AdventHealth Parker Expansion

RE: AdventHealth Parker Expansion

This letter serves as a Drainage Conformance Letter for the proposed AHP Expansion. This letter references the "Final Drainage and Erosion Control Report for the Parker Adventist Hospital", prepared by S. A. Miro, Inc., dated May 1, 2002. The latest update to the report was for the Medical Office Building III, prepared by S. A. Miro, Inc., dated November 2018.

Intensity Equation

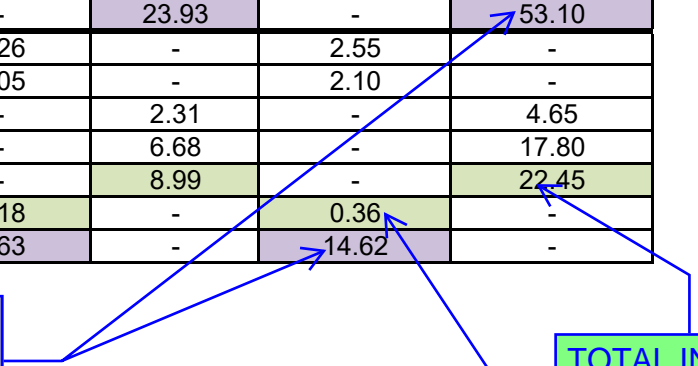
Please use latest NOAA Atlas 14 p rainfall values for Town of Parker in Hydrology calculations and provide reference to the data used in this report. Parker is in the process of updating the SDECM to reflect this requirement.

DETENTION BASIN OUTLET STRUCTURE DESIGN

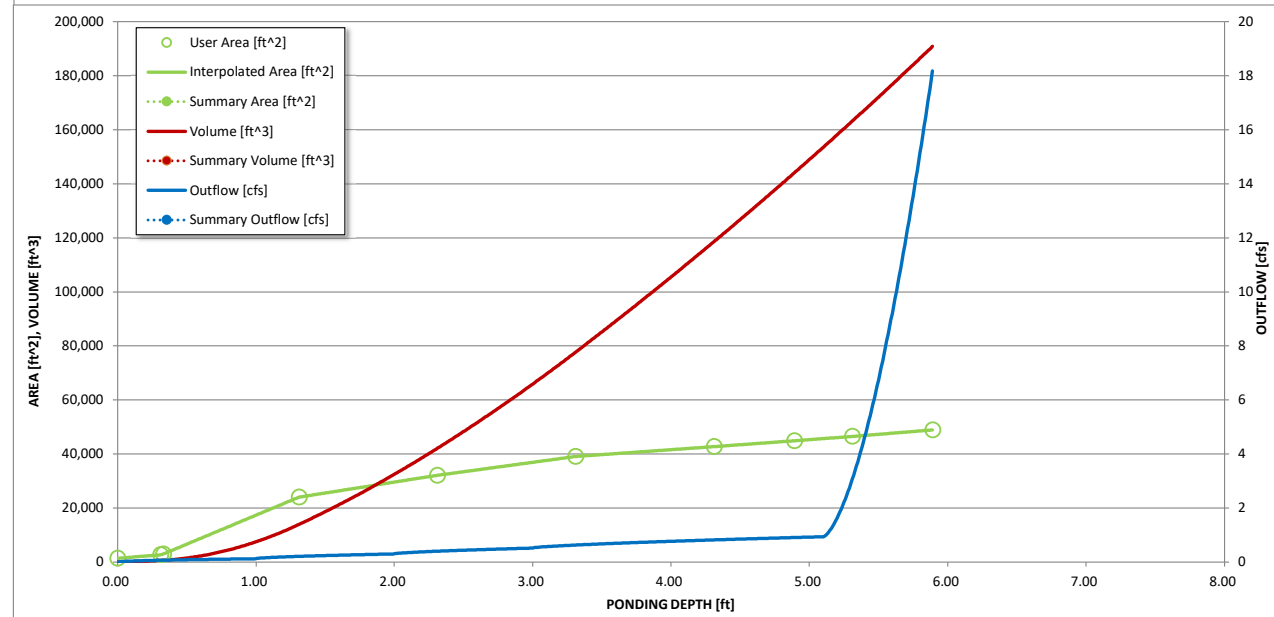
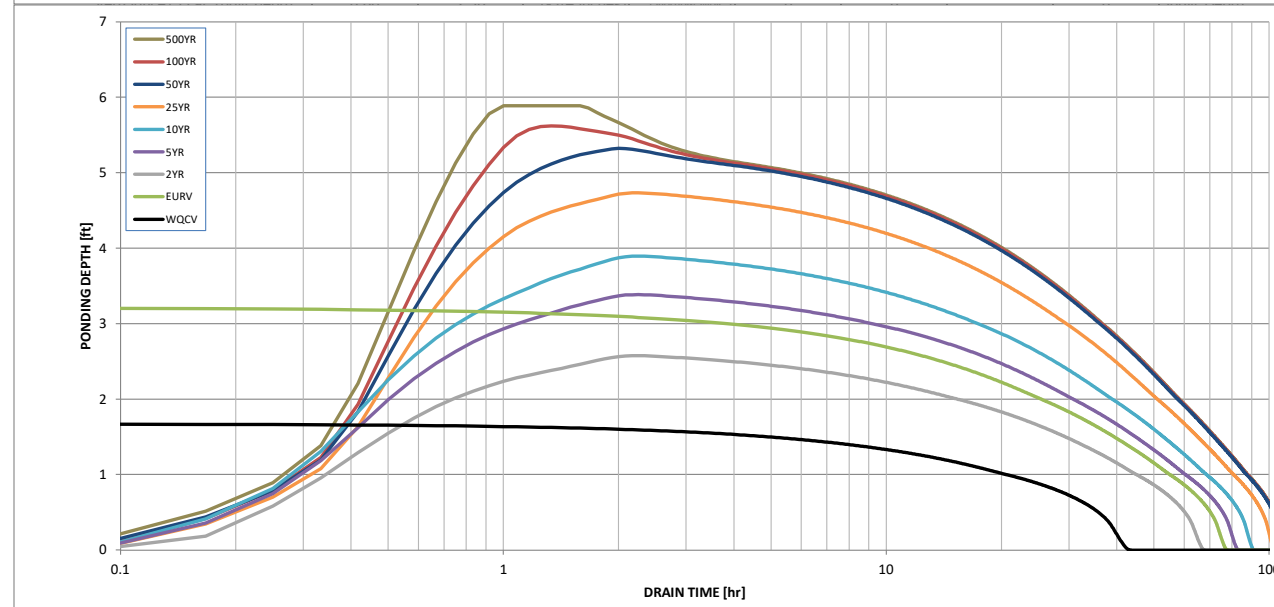
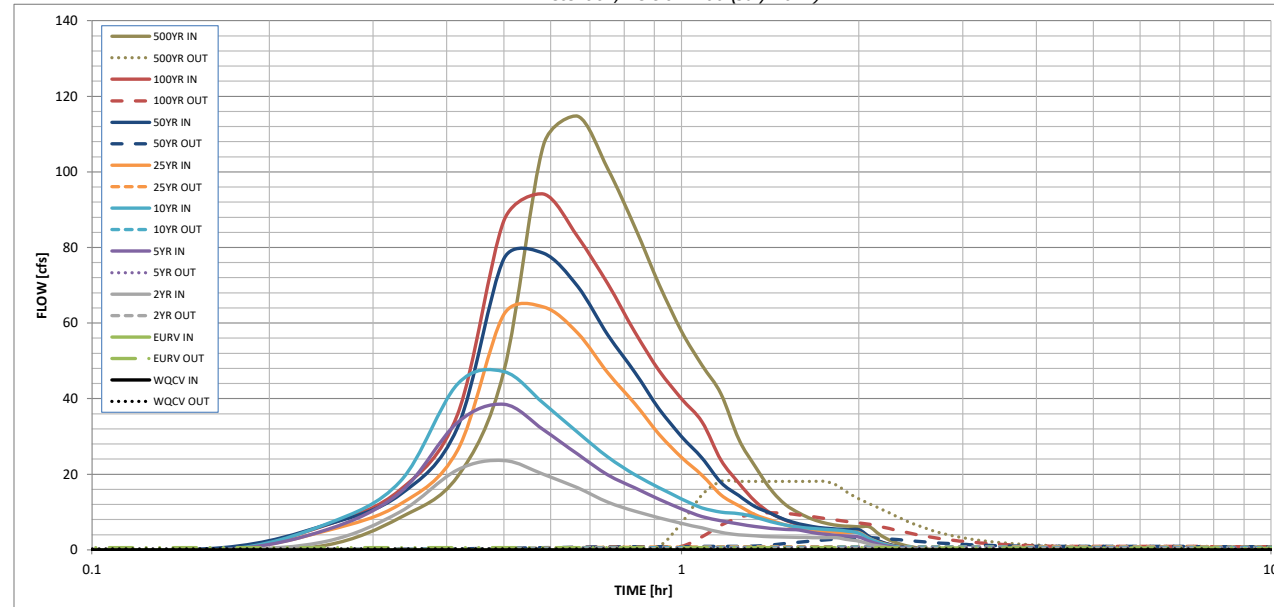
The minor and major storm event ratio of peak outflow to pre-development flow should be closer to 1

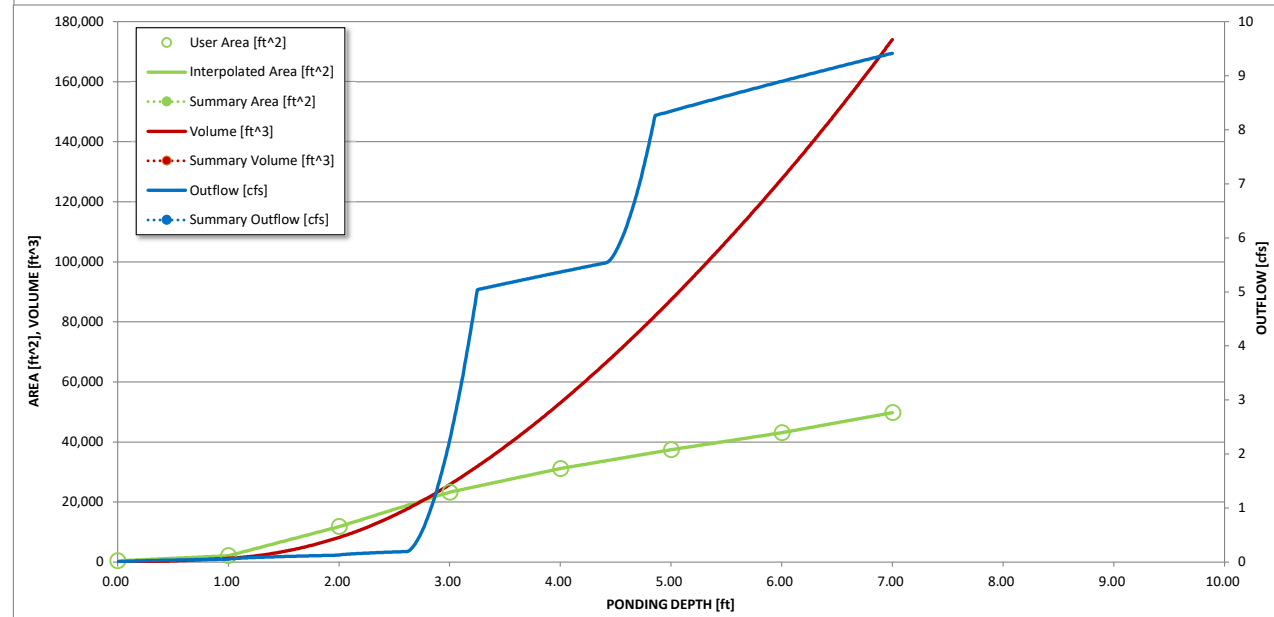
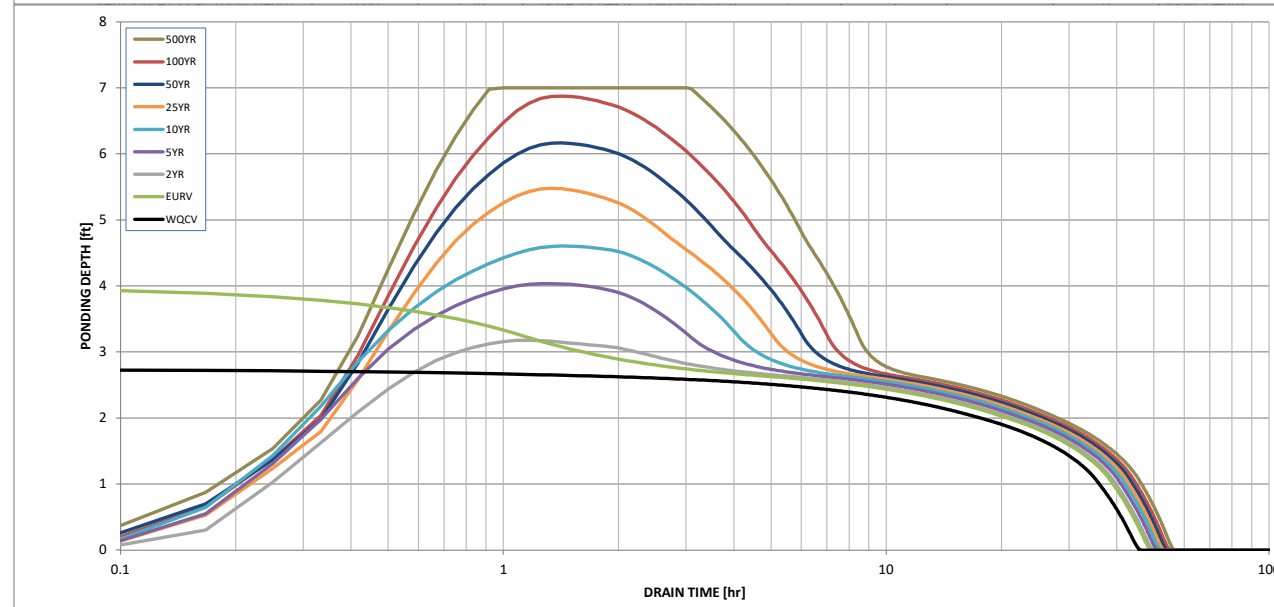
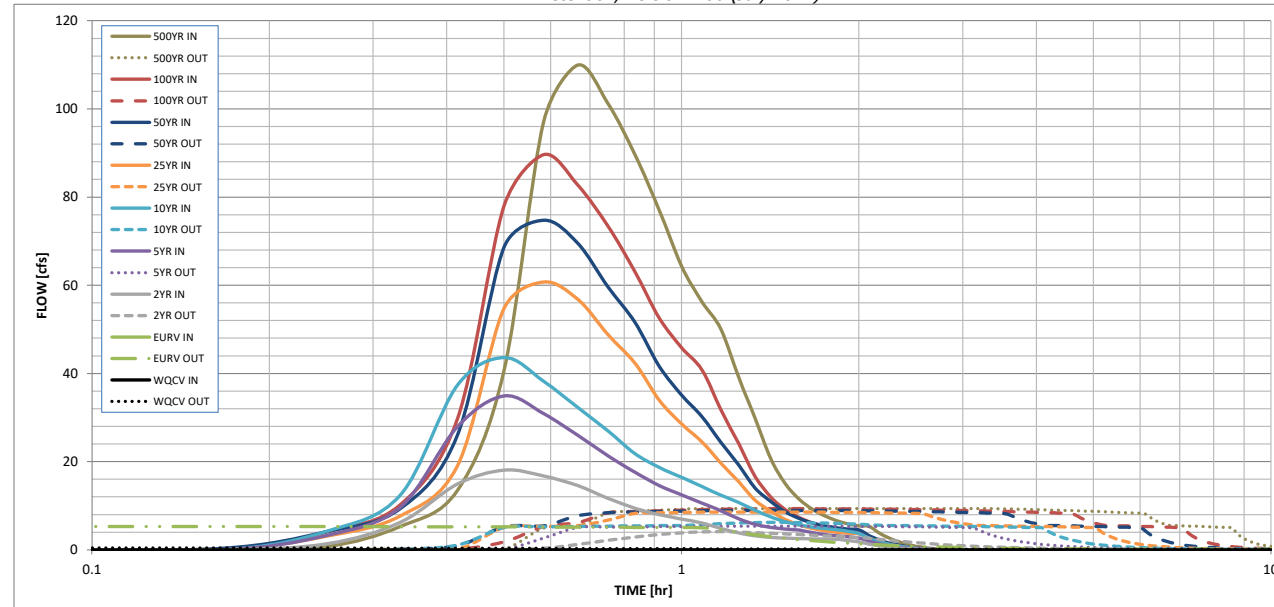
Please evaluate the design calculations of modified Pond B accommodates the 1-foot of freeboard requirement.

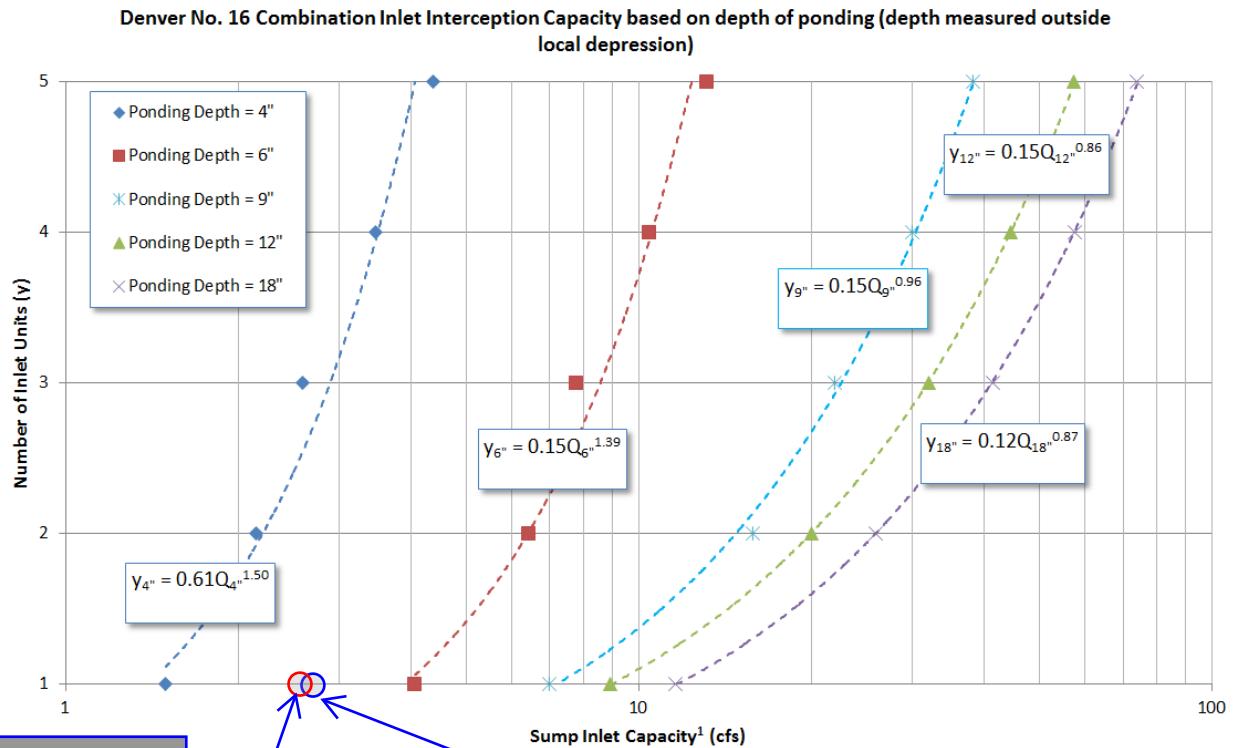
Please provide a summary table of results for inlet capacity and ponding depths with inlet labels. These results appear to differ significantly from what is shown in StormCAD results.

2.55 CFS AT BASIN G8. BETWEEN 4" & 6" OF PONDING IN 100-YR STORM AT TYPE 16 INLET

SEE SHEET FIG. 1.2

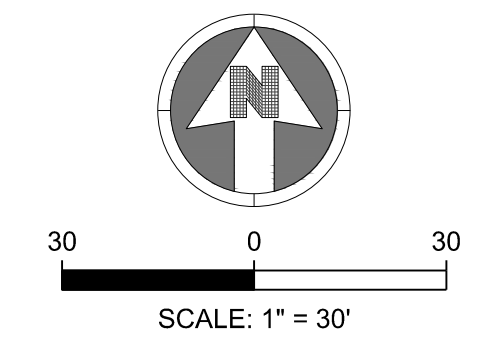
Please include a Key Map
